**AGENDA
HISTORIC PRESERVATION
REGULAR MEETING
CITY HALL COUNCIL CHAMBERS
109 EAST OLIVE STREET; BLOOMINGTON, IL 61701
THURSDAY, SEPTEMBER 20, 2018, at 5:00 P.M.**

CITY OF BLOOMINGTON
REPORT FOR THE HISTORIC PRESERVATION COMMISSION
SEPTEMBER 20, 2018

CASE NO:	TYPE:	ADDRESS	SUBJECT:	REPORT BY:
BHP-21-18	Rust Grant	414 N Main St.	New entryway	Izzy Rivera Assistant City Planner

CASE NO:	TYPE:	ADDRESS	SUBJECT:	REPORT BY:
BHP-22-18	Rust Grant	111-113 E Monroe St	Roof top patio	Izzy Rivera Assistant City Planner

DRAWING TITLE:
SD2.1
FLOOR PLAN
AND ELEVATION

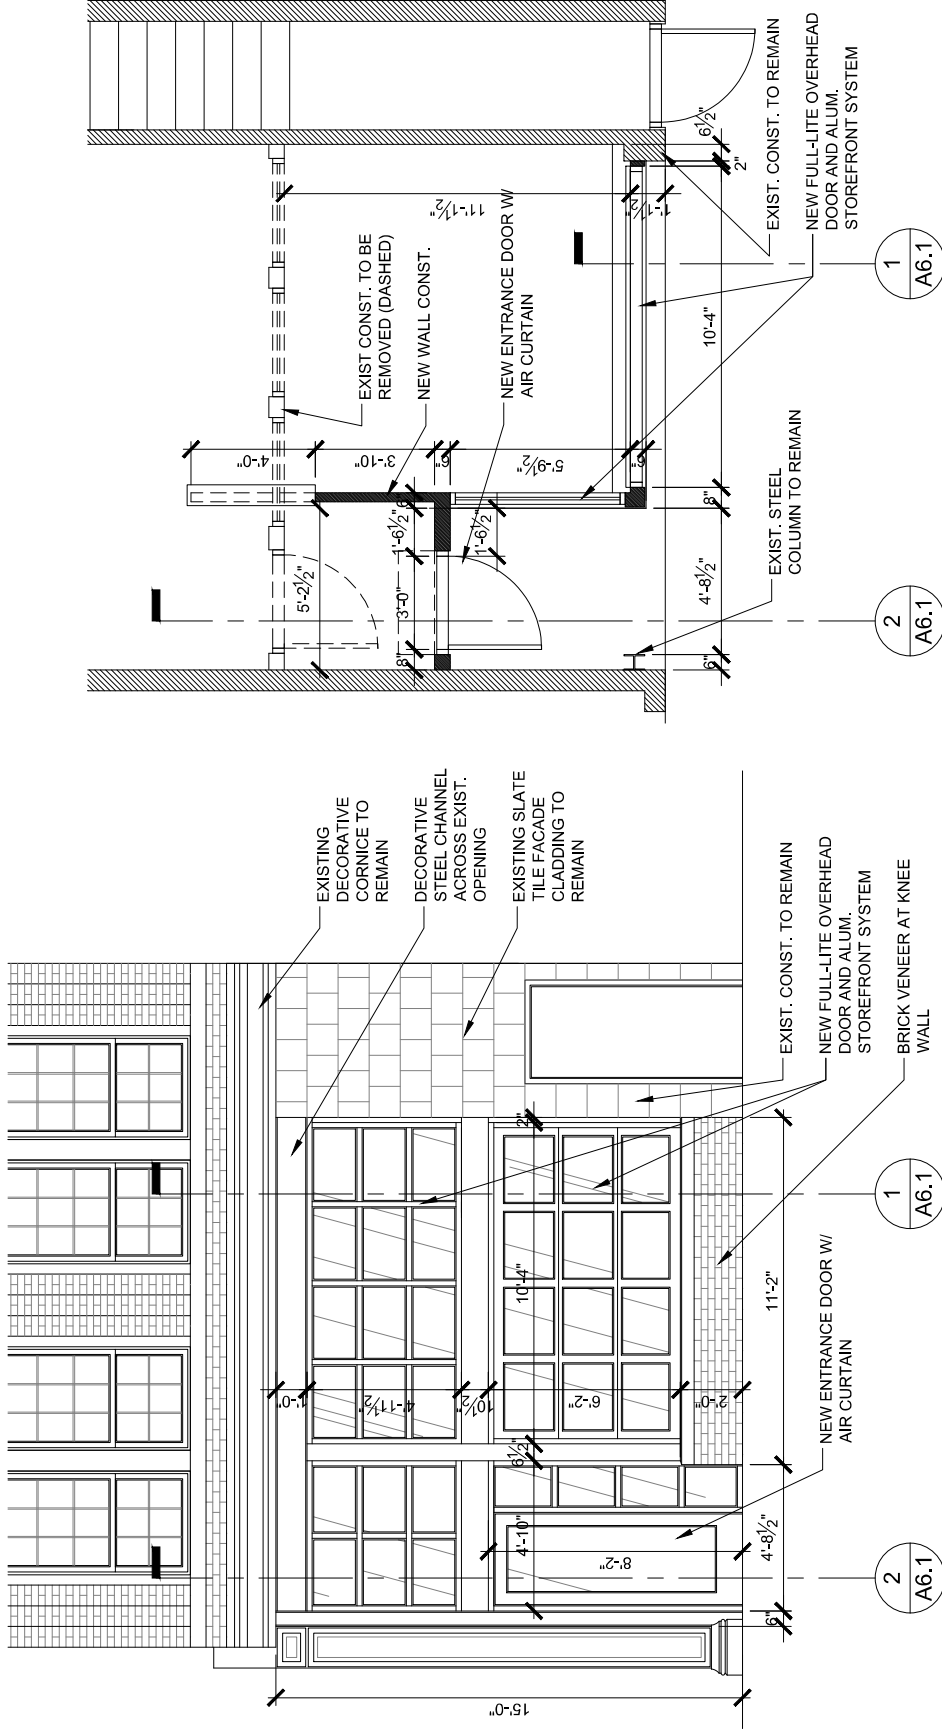
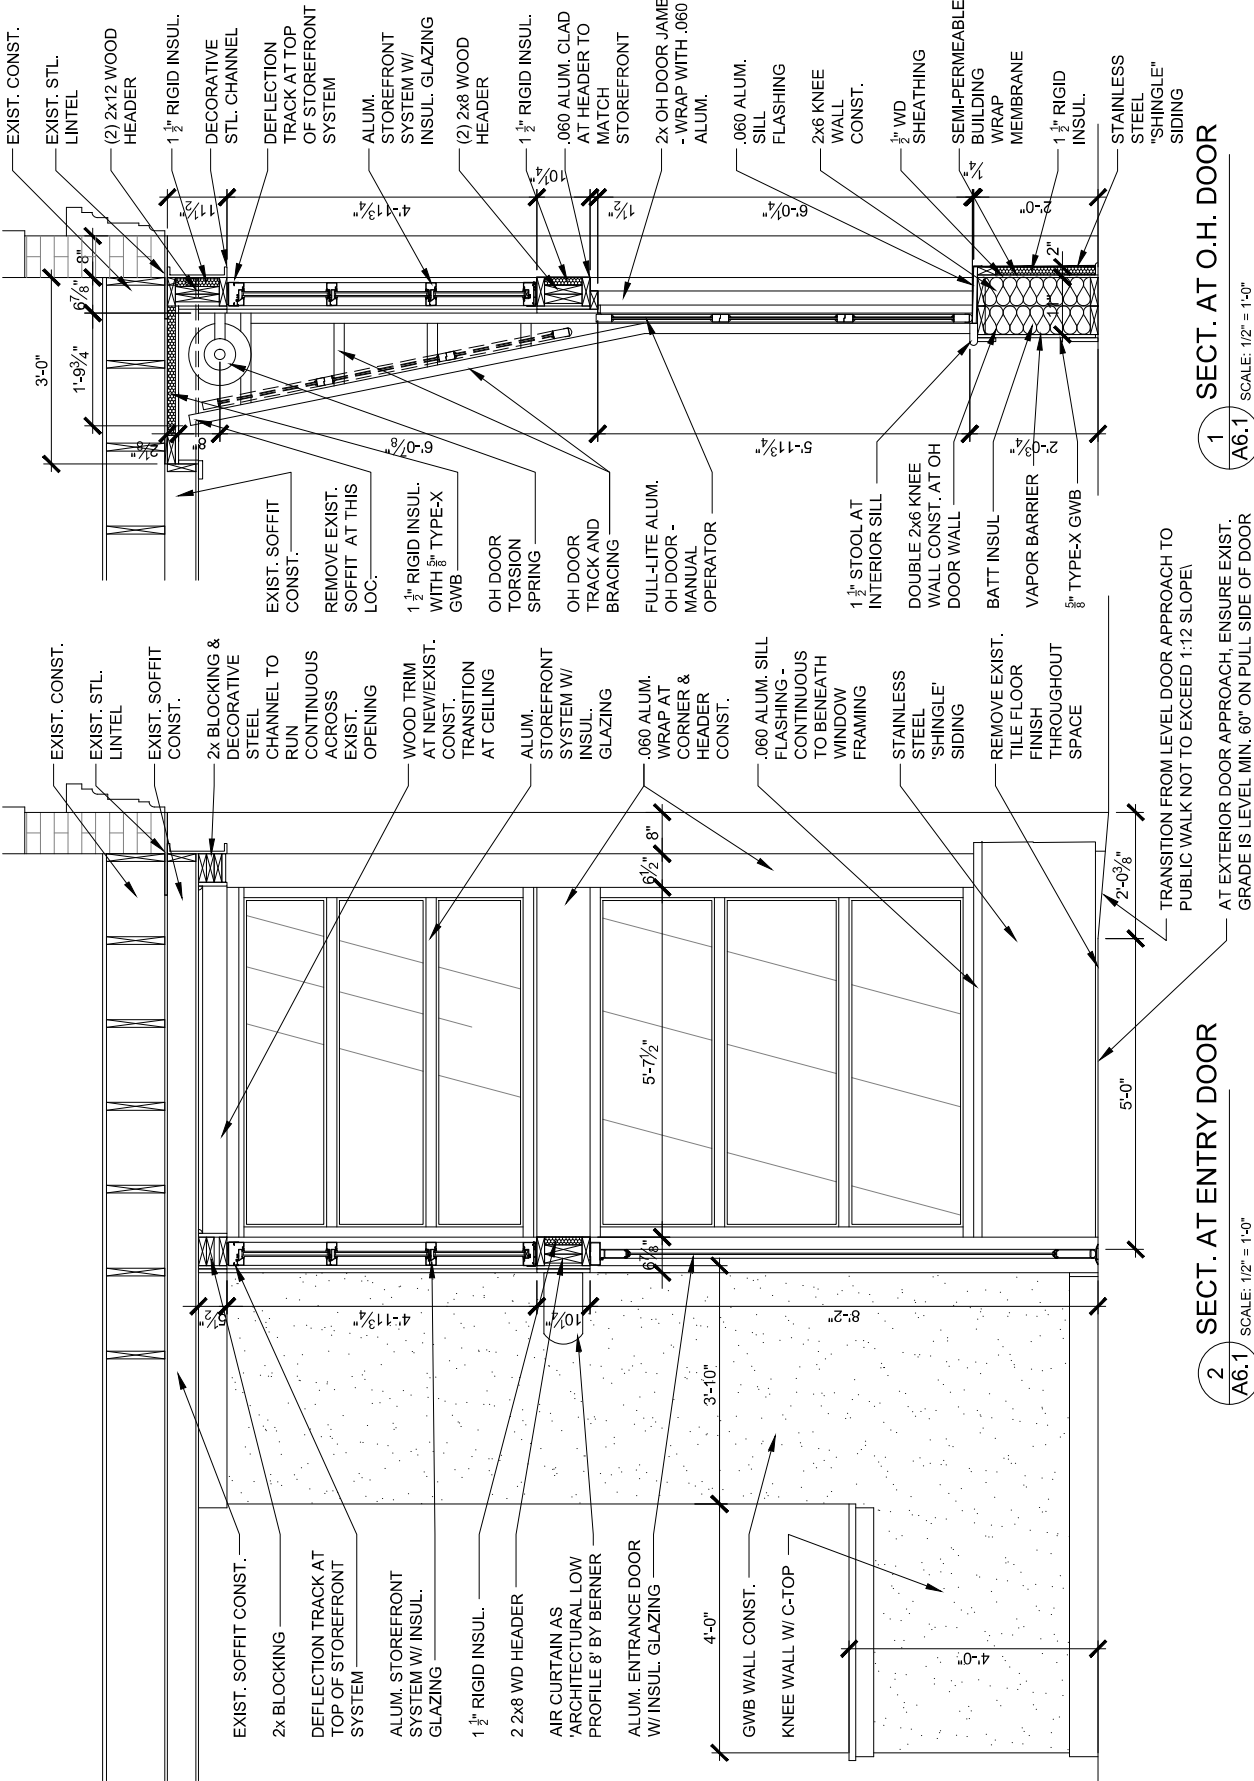
Ms. Cline stated the Commission should consider requesting additional information, such as a rendering from the manufacturer that can imitate the existing windows for a more uniform appearance. Mr. Scharnett stated that slate that is shown on the rendering should be changed to reflect what the petitioner will be installing. The rendering should reflect a less industrial style and a more historic feel. Ms. Cline added this could be achieved with the details. Mr. Elterich asked if the door will have an aluminum look to it, Mr. Vericella stated it will be painted black. Ms. Simpson asked if the Commissioners had an example of a building downtown that had the scaling between the windows that they would like to see for this project. Ms. Cline stated she would like the petitioner to use the existing windows on the upper floors as a guide for the storefront. Mr. Vericella stated the windows will have to be somewhat rectangular in order for them to open. The Commission agreed that they would like to see something more historical that goes along with the neighborhood and it not so trendy.

Remodeling of a storefront on a contributing structure should be historically relevant and complement the existing structures. However, staff was unable to find a historic photograph to confirm the original storefront. Changes throughout the years could have been made which have removed original features. The corridor along the block consists of glass store fronts and several awnings. The site directly west of the subject property has a transparent window façade as well. Transparent, majority window storefronts, ensure visibility into spaces and appear inviting for pedestrians. This will continue to promote walkability in the downtown, and promote retail use. The store front at 414 N Main St. will also become flushed with the building and eliminate the outdoor seating patio. This will also add to the uniformity of the corridor. According to the Historic Preservation Brief 11, “Rehabilitating Historic Storefronts” material, window style and color should be taken into consideration in order to contribute, and compliment the surrounding structures.

Ms. Cline motioned to table case BHP-21-18 giving the owner the opportunity to revisit the style of the garage door, and consult an architect on structural issues. Seconded by Mr. Elterich. The motion was approved 4-0 with the following votes cast in favor on roll call: Ms. Cline—yes; Mr. Elterich—yes, Mr. Scharnett—yes; Chairperson Graehling—yes.
